REVISION NO. 6 **JUNE 24, 2016**

THE MEDICAL CENTER OF AURORA RENOVATIONS
Aurora, Colorado

ESa PROJECT NO. 14077.00

These revisions form a part of the Contract Documents and modify the original CONSTRUCTION DOCUMENTS, dated December 30, 2014, as outlined here in addition to being shown on the drawings as Delta No. 6, dated June 24, 2016.

A1.04.1

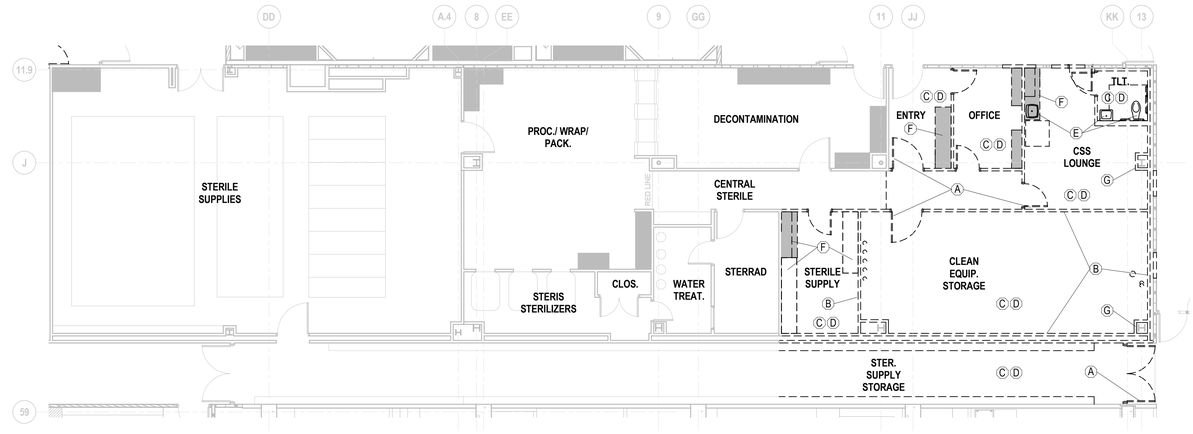
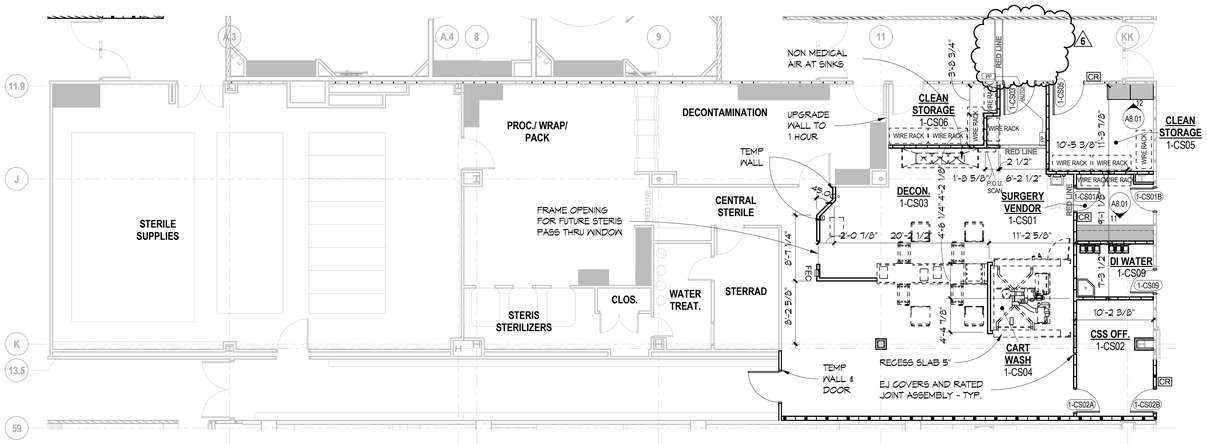
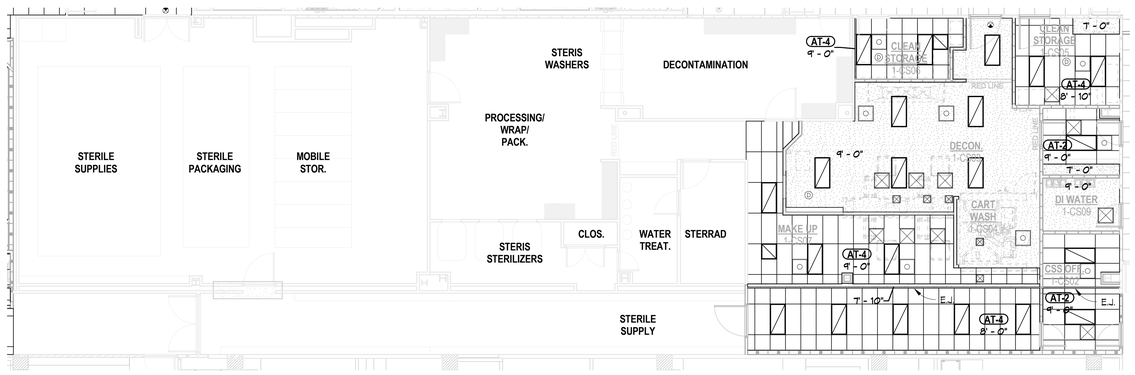
A1.04.1– PHASE IV - SPD
1. Redline adjusted per Owner request.

A1.06

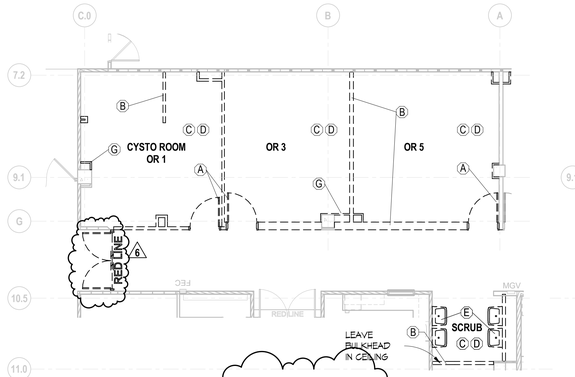
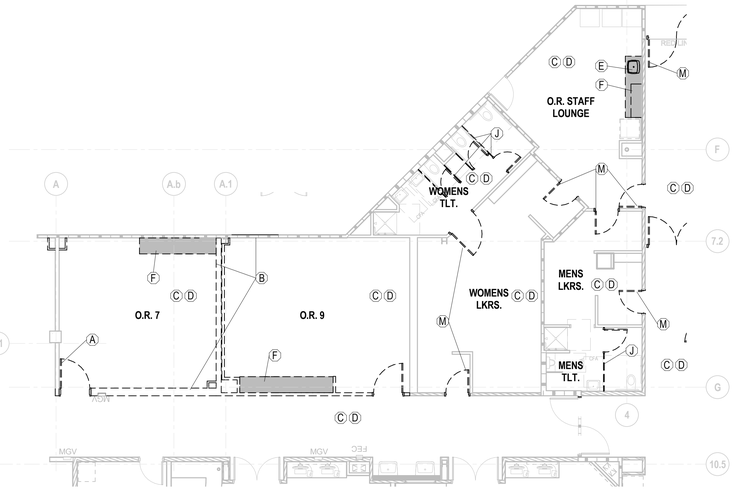
A1.06– PHASE VI-A & VI-B
1. Equipment Storage 1-SS125 added.
2. Phase names updated.

9 RCPT/SCHED. 1-SS112 B
SCALE: 3/8" = 1'-0"

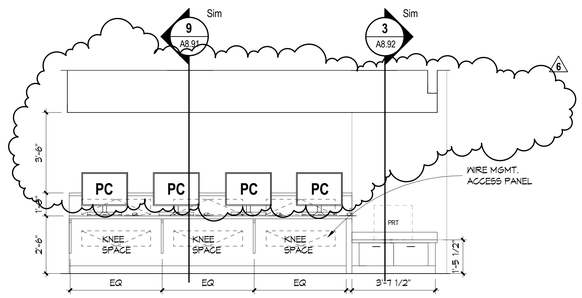
1. Glass removed in 1-SS112B per Owner request.

FIRST FLOOR PART B REFLECTED CEILING PLAN

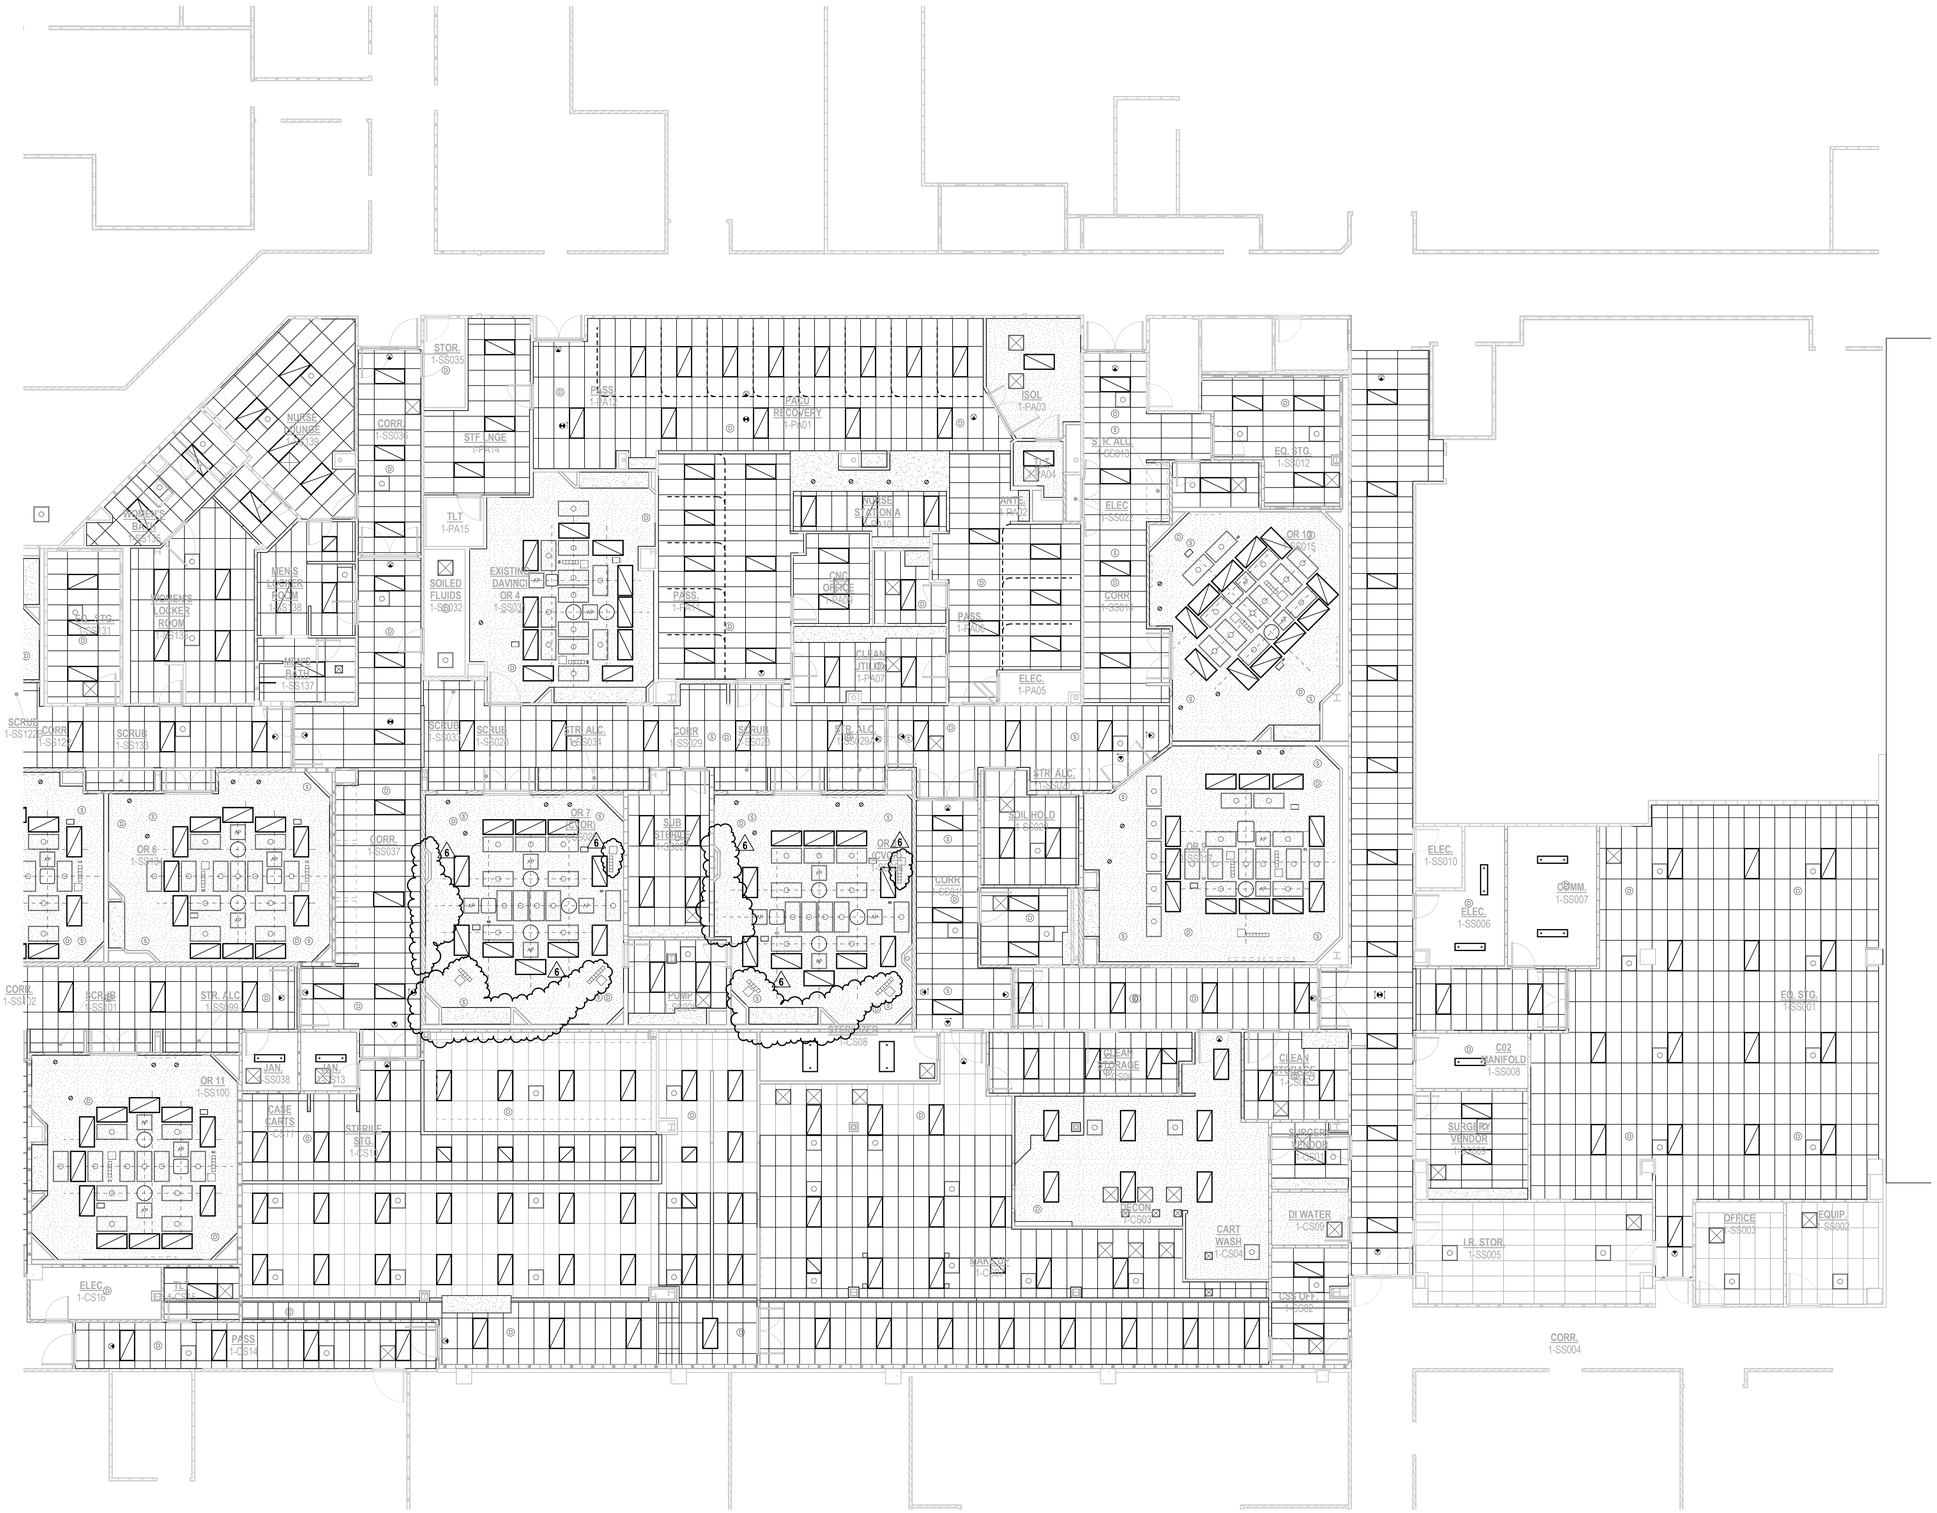
1. Ceilings in O.R. 7 & 8 updated due to plan changes.

E1.03

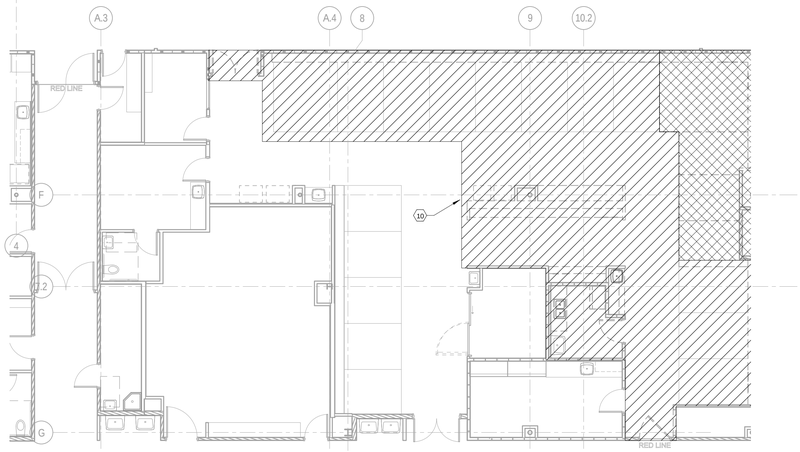
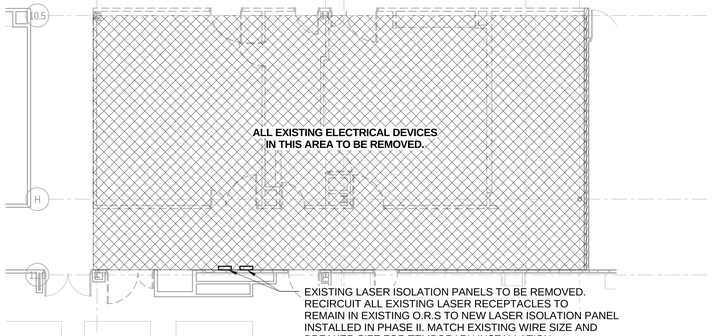
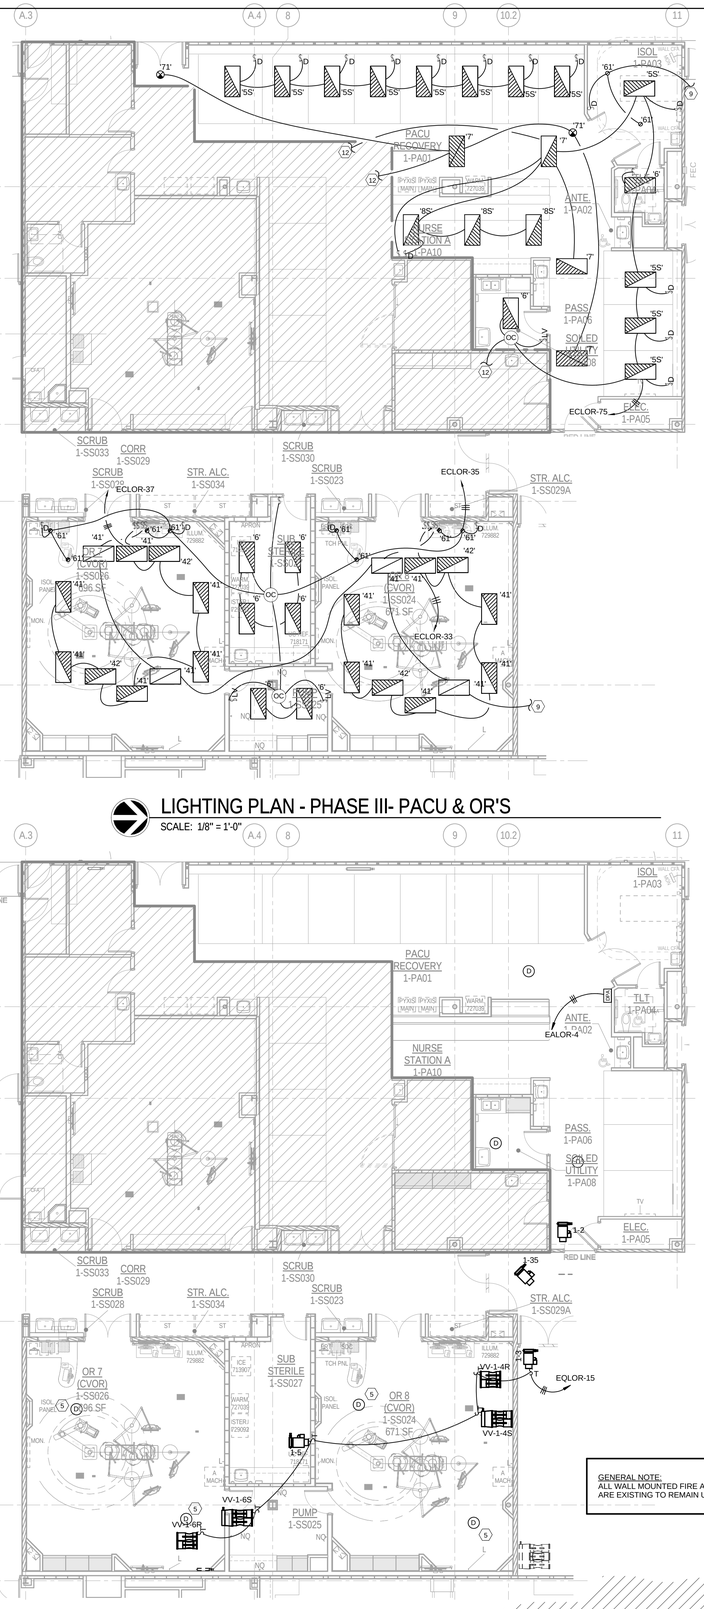
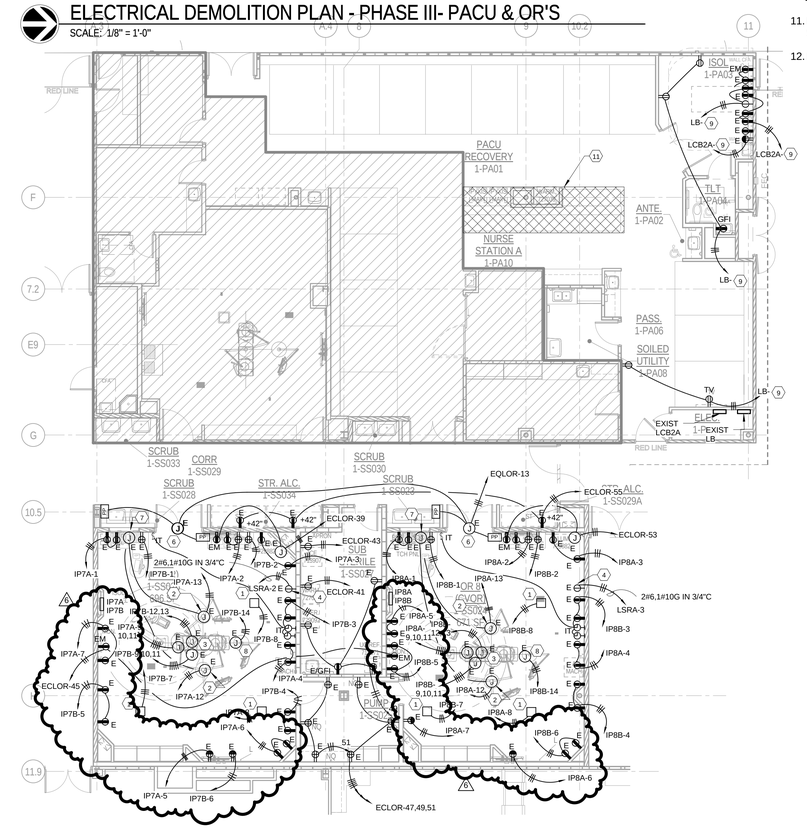
1. Revised receptacle layout and location of isolation panels in OR's 7 and 8 to reflect base plan changes.

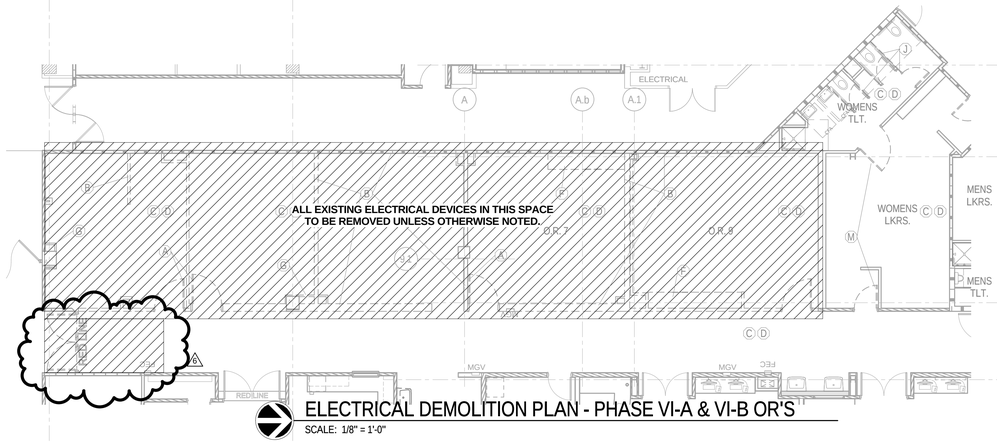
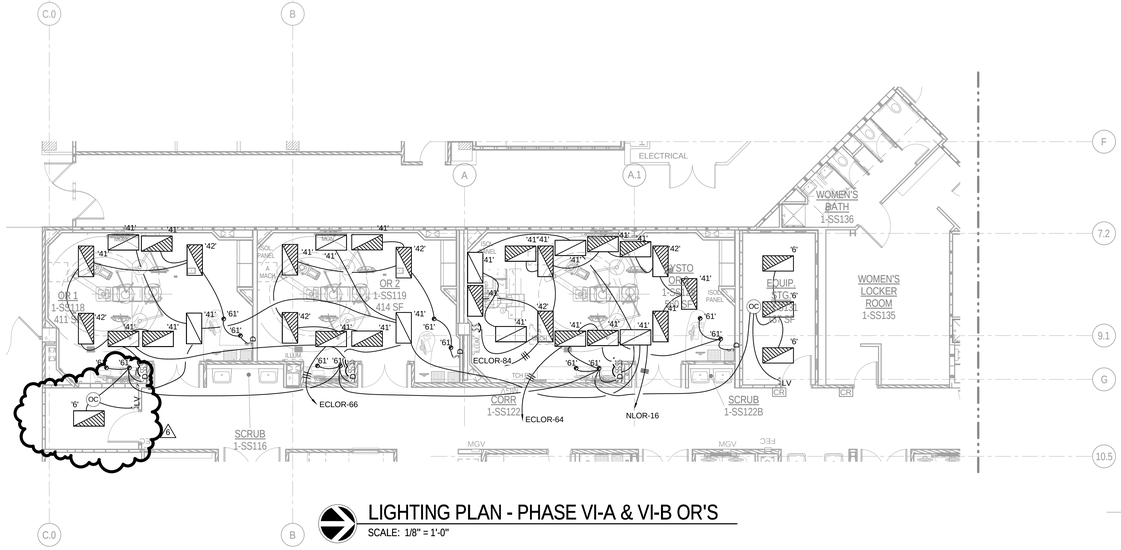
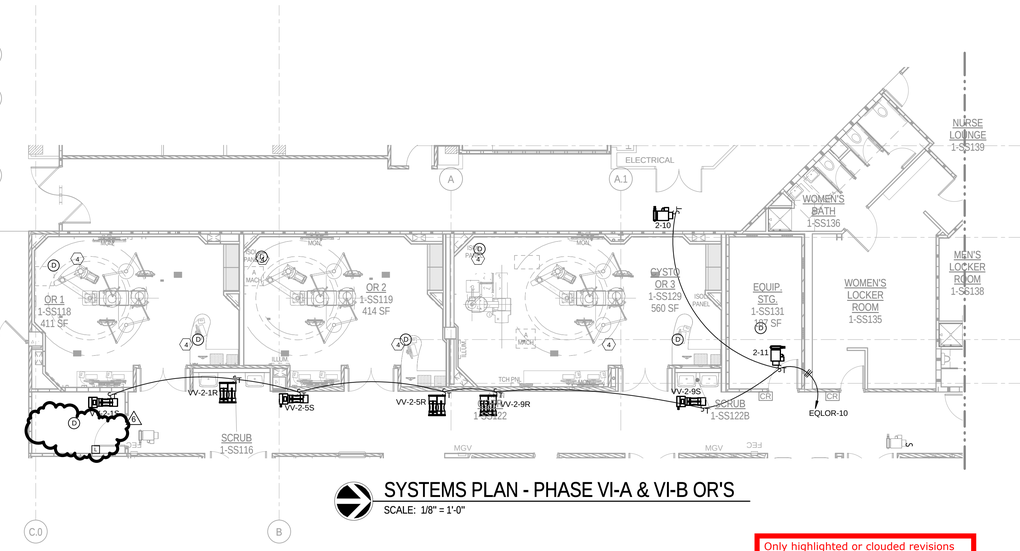
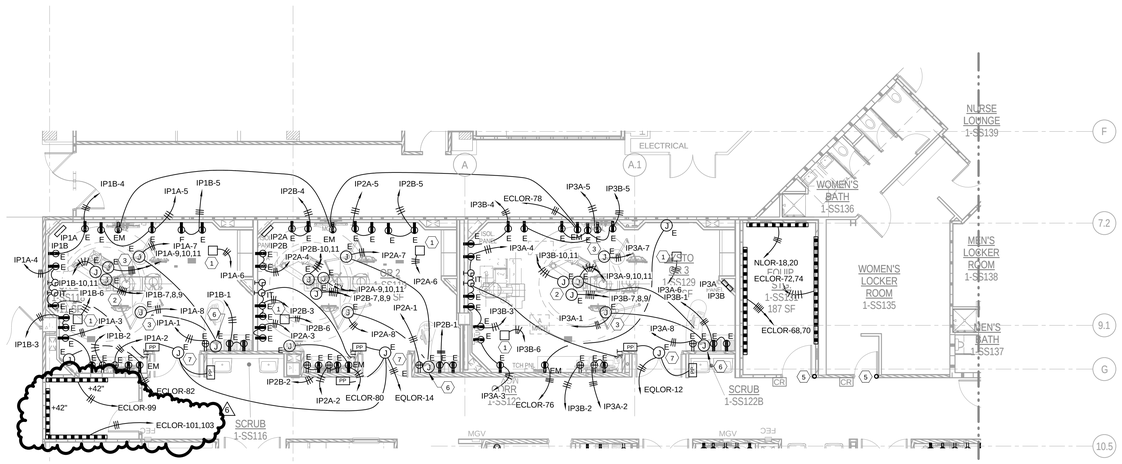
1. Added lighting and power in new equipment storage room to reflect base plan changes.
